## SUNDRY NOTICES AND REPORTS ON WELLS

2. NAME OF OPERATOR  
Merrion Oil & Gas Corporation

TEST WATER SHUT-OFF	<input type="checkbox"/>
FRACTURE TREAT	<input type="checkbox"/>
SHOOT OR ACIDIZE	<input type="checkbox"/>
REPAIR WELL	<input type="checkbox"/>
PULL OR ALTER CASING	<input type="checkbox"/>
MULTIPLE COMPLETE	<input type="checkbox"/>
CHANGE ZONES	<input type="checkbox"/>
ABANDON*	<input type="checkbox"/>
(other) Corrected Plat

# WELL LOCATION AND ACREAGE DEDICATION PLAT

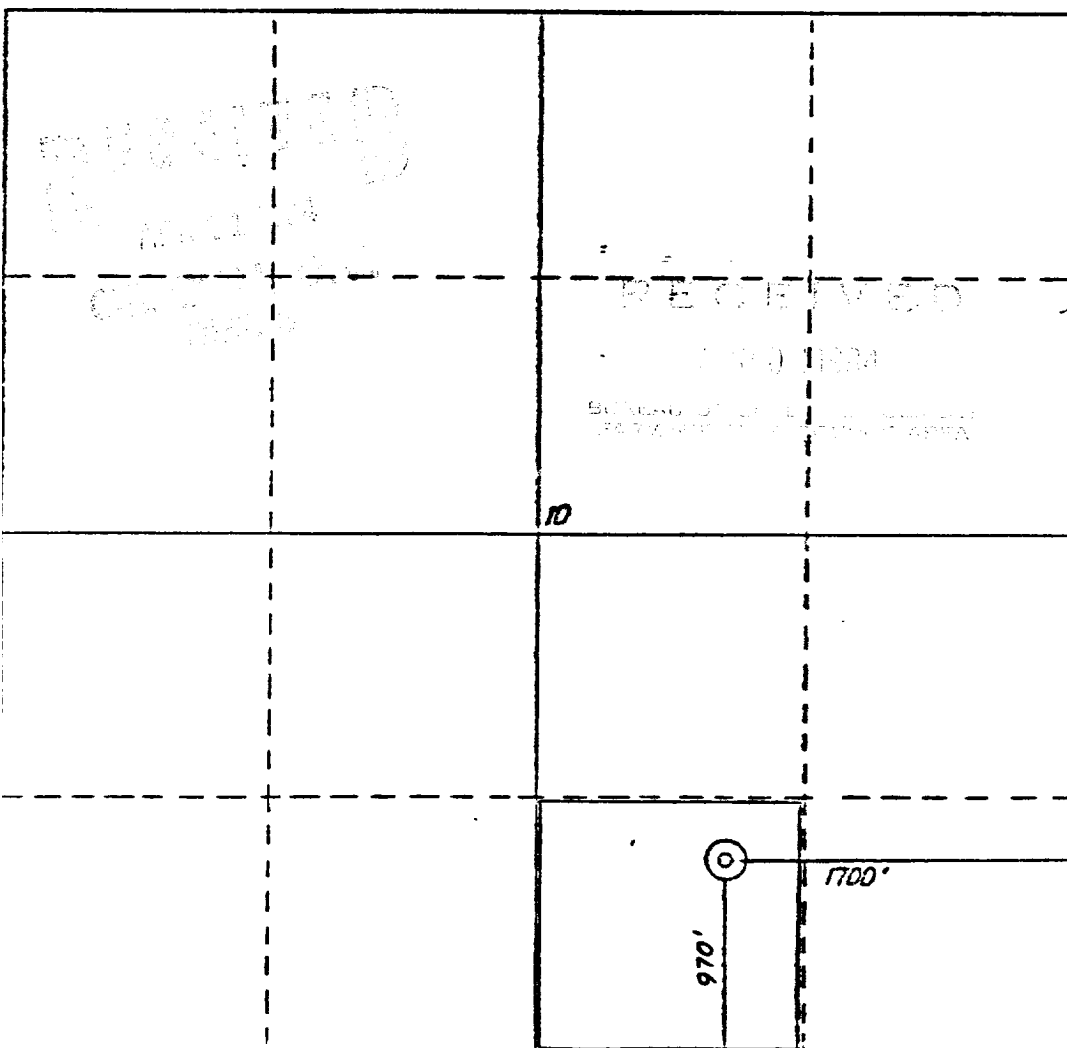
Attached is a corrected plat indicating 160 dedicated acres and the correct footage of 970' FSL and 1700' FEL.
